LAND USE APPLICATION SUMMARY

Property Location: 1405 E Lake St
Project Name: The Lofts on East Lake
Prepared By: Peter Crandall, City Planner, (612) 673-2247
Applicant: Monty Realty, LLC
Project Contact: Christine Charles
Request: To build a mixed-use addition to an existing commercial building.
Required Applications:

Site Plan Review	For a mixed-use addition to an existing commercial building.
-------------------------	--

SHEET TITLE:
**EXTERIOR
 ELEVATIONS**

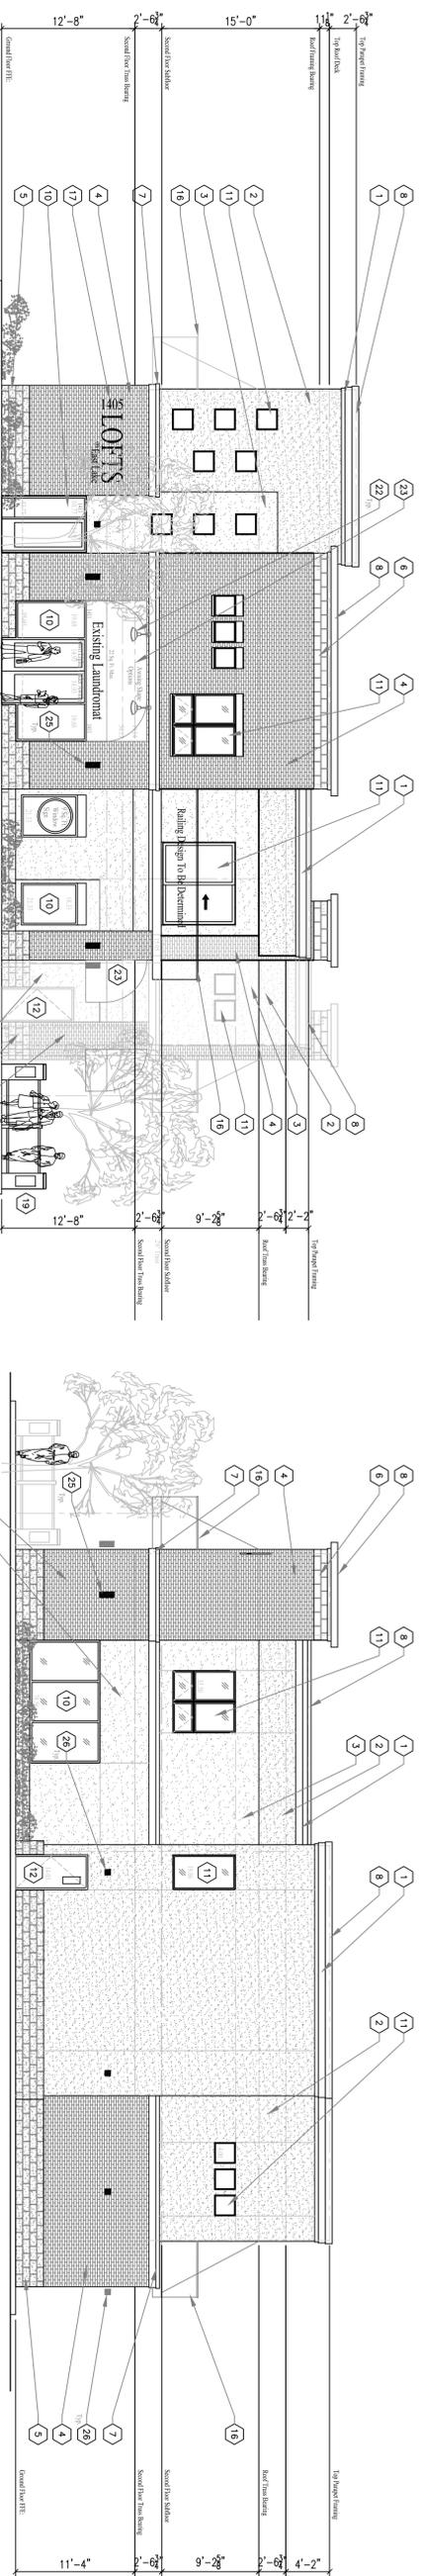
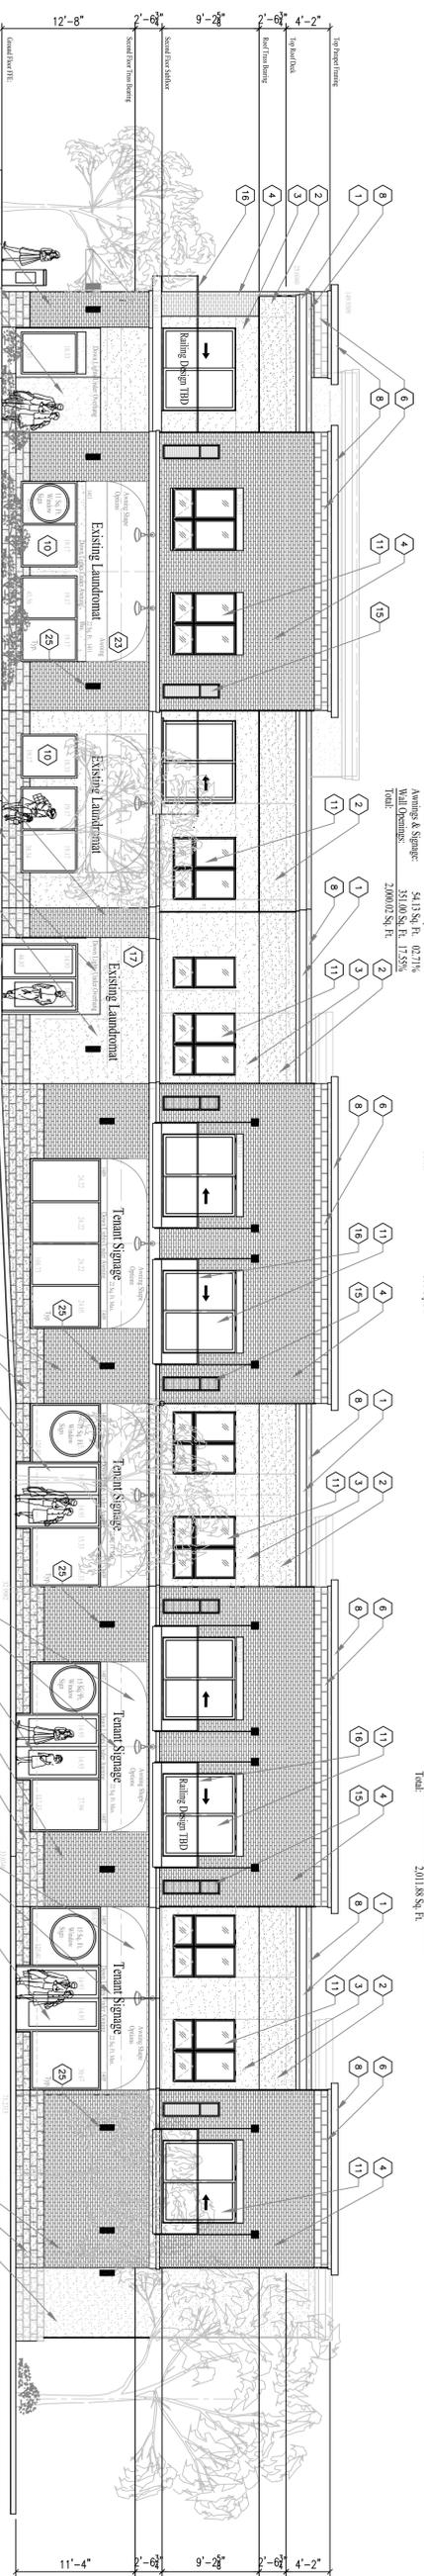
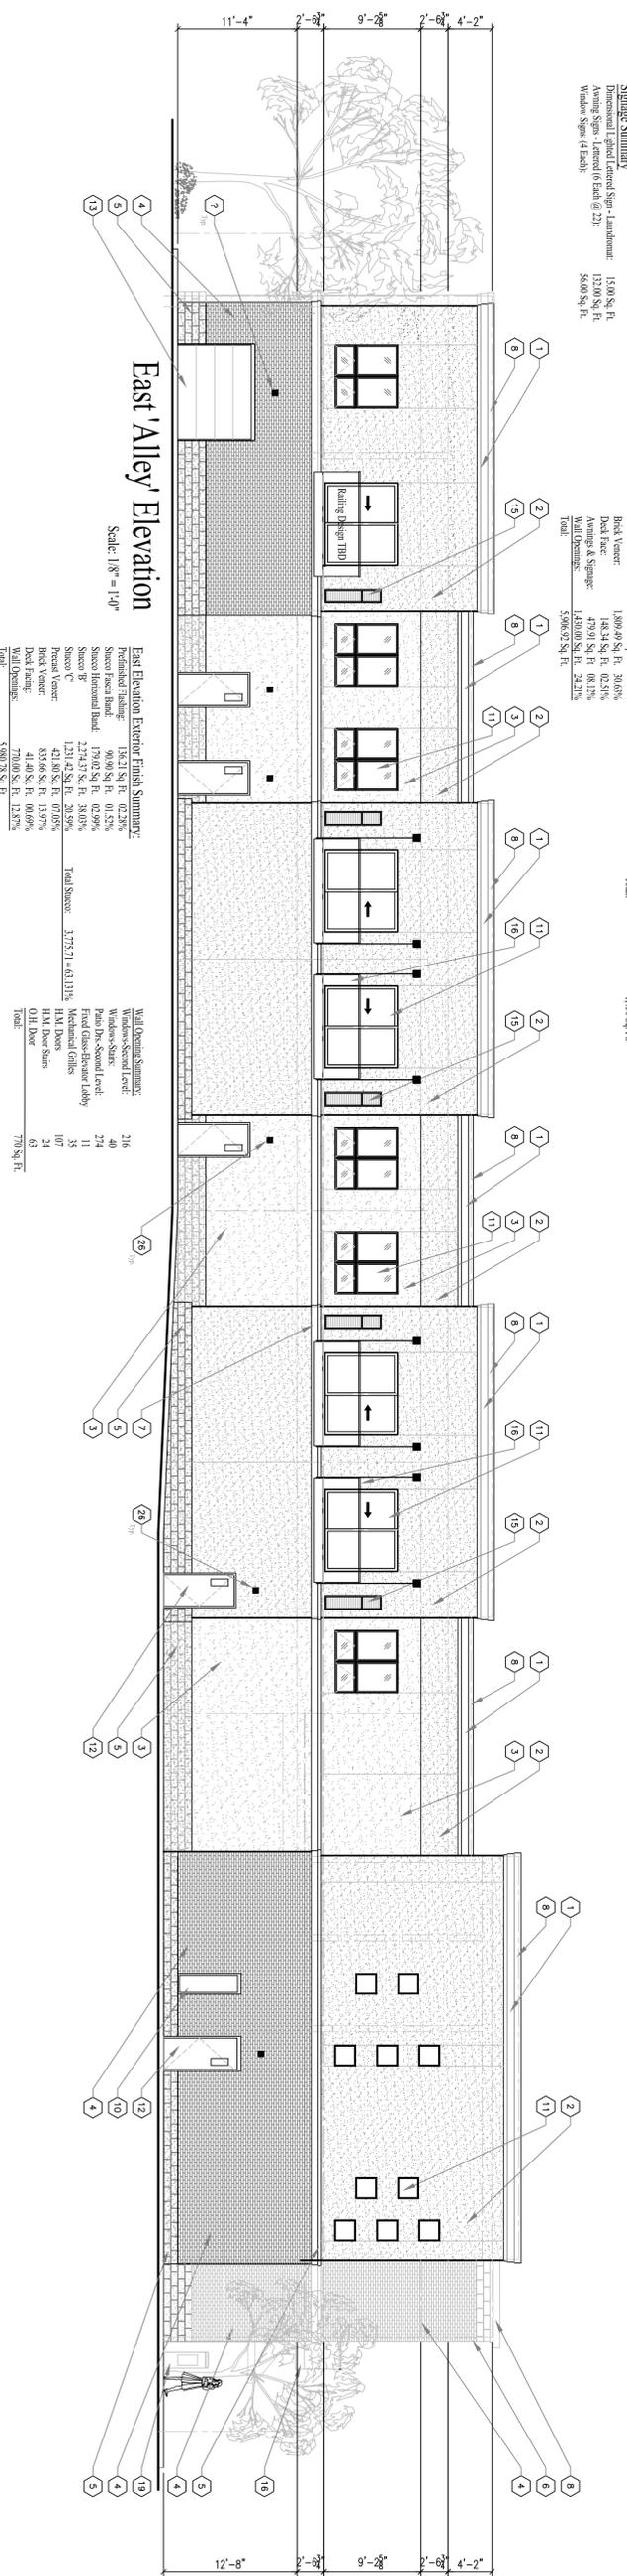
- **Visual Interest.** The East façade along the alley way contains blank walls of more than 25 ft. in length. There are some material changes as well as recesses and projections. Additionally, the applicant is providing for some landscaping and planting between the alleyway and the building wall adding to the pedestrian experience in both the alley and along the back of the building. Staff is recommending that the Planning Commission grant alternative compliance for this requirement.
